BCA & DDA/Access Capability Statement

Atwea College Woodberry
42A Kookaburra Parade, Woodberry NSW

21 November 2024
Reference: N240146

Figure 9: Non-Compliant Lock

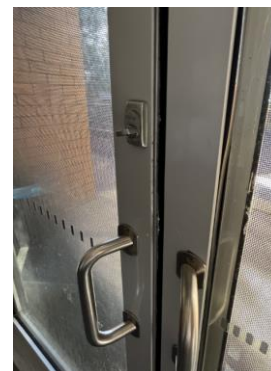
Comment: Non-complaint hardware and locking mechanisms are installed in numerous existing internal and exit doors.

Door hardware that does not provide free egress by non-slip, single action hardware is the is to be replaced throughout. Any locking mechanisms that require a key and / or cannot be unlatched with the lever action must be removed from exit doors and upgraded as part of the change of use.
